FRONT TUBE CAP Prevost vehicles

On the vehicles affected by this bulletin, add caps on openings at front structure bottom corners.

Figure 1

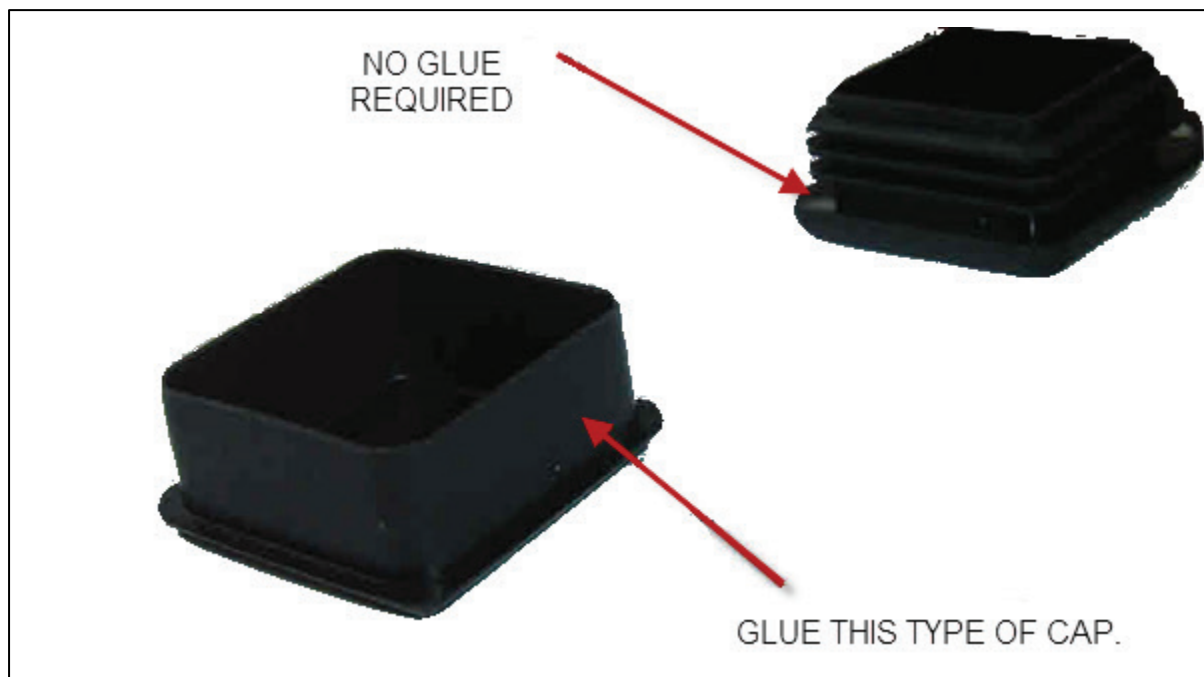
- 1) At the bottom of vertical members on the front structure bottom corner, add cap #508394 (Fig. 1)
- 2) If cap does not have ribs (Fig. 2) ,glue with Simson ISR 70-03 Black Glue.
